World Forum for Harmonization of Vehicle Regulations**Working Party on Lighting and Light-Signalling****Seventy-third session**

Regulation No. 48 (Installation of lighting and light-signalling devices) –**Other proposals for amendments to Regulation No. 48****Proposal for the 07 series of amendments to Regulation
No. 48 (Installation of lighting and light-signalling devices)****Submitted by the experts from the International Organization of Motor
Vehicle Manufacturers (OICA) and the International Automotive
Lighting and Light Signalling Expert Group (GTB)***

The text reproduced below was prepared by the experts from OICA and GTB to introduce new criteria on the automatic levelling of headlamps based on the GTB glare and visibility studies. This proposal is for formal consideration and advice from Contracting Parties, with the expectation that a finalised text will be submitted for adoption at the seventy-fourth session of GRE. The modifications to the existing text of the Regulation are marked in bold for new or strikethrough for deleted characters.

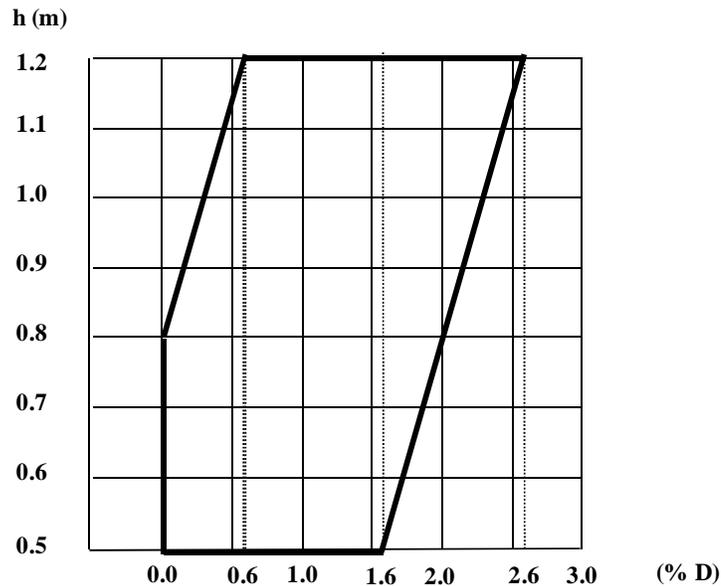
6.2.6.1.1.2. **Depending on the mounting height in metres (h) of the [lower edge of the apparent surface in the direction of the reference axis of the dipped-beam headlamp], measured on the vehicles under the loading conditions prescribed in Annex 5 of this Regulation, the downward inclination of the cut-off of the dipped beam headlamp, starting from the initial inclination value set by the vehicle manufacturer as prescribed in paragraph 6.2.6.1.1.1. above, shall remain between the limits (see diagram below):**

**h = 0.5 m: from 0.0 per cent to -1.6 per cent;
h = 0.8 m: from 0.0 per cent to -2.0 per cent;
h = 1.2 m: from -0.6 per cent to - 2.6 per cent.**

For the intermediate mounting heights, the limits vary linearly between the indicated values.

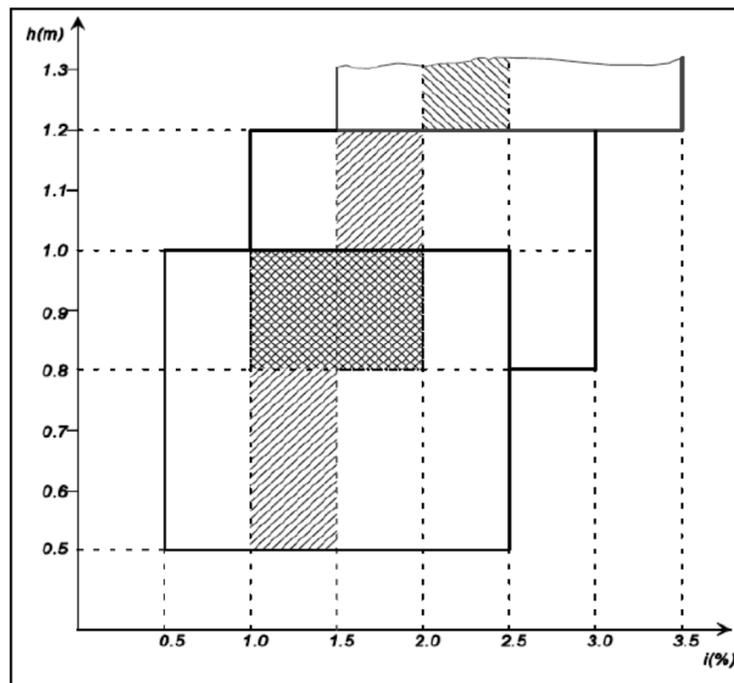
6.2.6.1.2.2. Depending on the mounting height in metres (h) of the lower edge of the apparent surface in the direction of the reference axis of the dipped-beam headlamp, measured on the unladen vehicles, the vertical inclination of the cut-off of the dipped-beam shall, under all the static conditions of Annex 5, remain between the following limits and the initial aiming shall have the following values:

$h \geq 1.0$

Limits: between -1.0 per cent and -3.0 per cent

Initial aiming: between -1.5 per cent and -2.0 per cent

The above limits and the initial aiming values are summarised in the diagram below.

Figure No. 1
Aiming limits and headlamp mounting heights

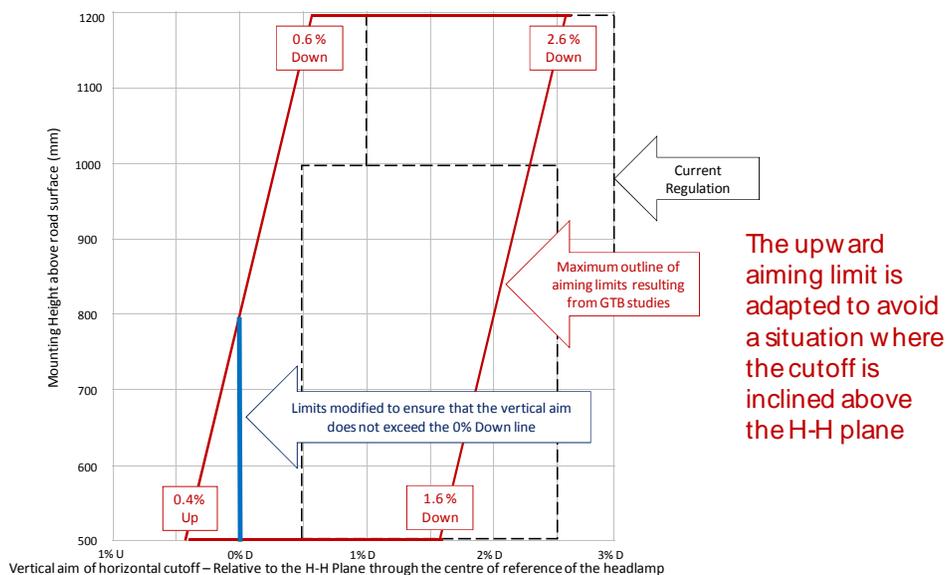
13. The presentation of the work of the GTB CAVGS task force to the seventy-first session of GRE concluded with a diagram showing the absolute aiming limits, resulting from the CIE calculations, to respect glare and visibility considerations for a range of headlamp mounting heights. Discussion at the seventy-first session of GRE revealed concerns of the contracting parties related to the aiming of the cut-off above the H-H line (above 0 per cent D) in the case of the lower mounting heights. The diagram was amended to take account of these concerns as follows:

14. In conclusion, the joint GTB / OICA proposal is to introduce a criterion to determine in which cases automatic static headlamp levelling shall be installed. This criterion is based upon the pitch of the vehicle resulting from the 50 per cent load distribution shown below. This replaces the existing 2,000 lumen criterion and so introduces a performance-based requirement instead of the current design restrictive requirement.

Figure No. 2
50 per cent loading

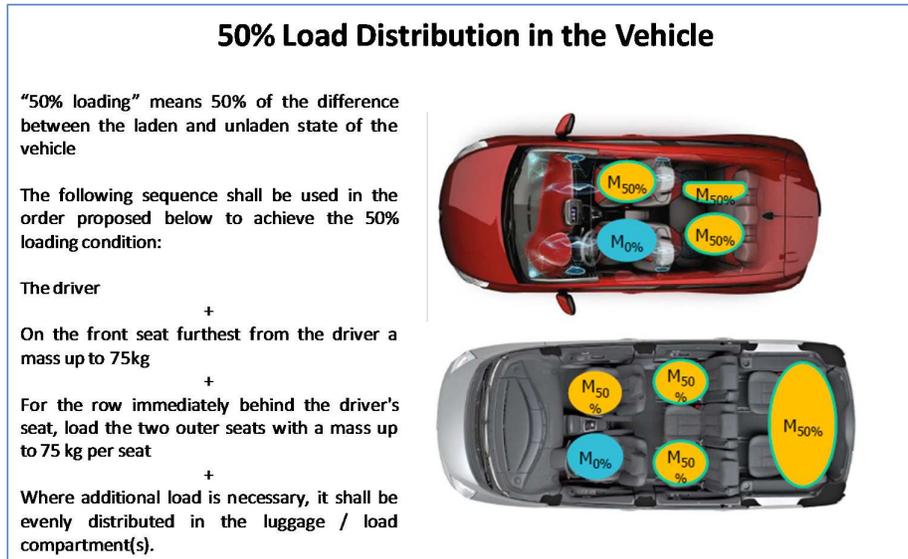
15. It is important to note that the "50 per cent loading" condition is in addition to the current loading conditions described in Annex 5 to Regulation No. 48.

Figure No. 3
Flowchart for levelling

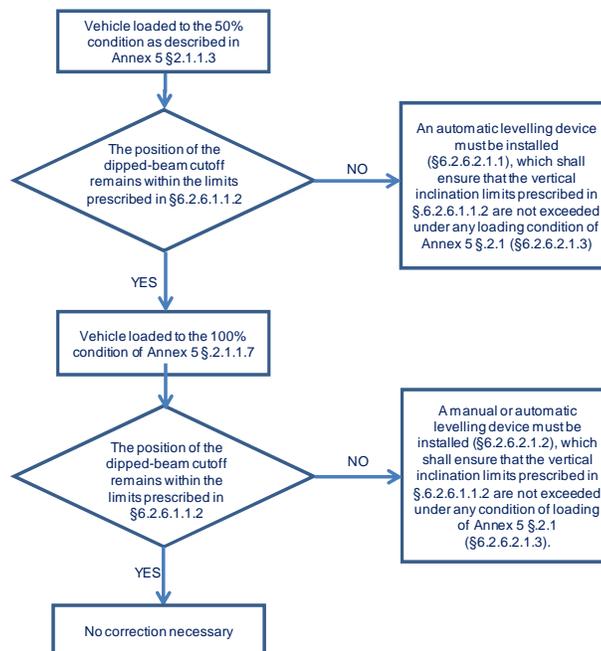
16. In the case where the application of the "50 per cent loading" criterion does not indicate mandatory automatic static headlamp levelling and the requirements of the "100 per cent loading" are not fulfilled, a manual or automatic levelling device shall be installed (please refer to the flow diagram below).
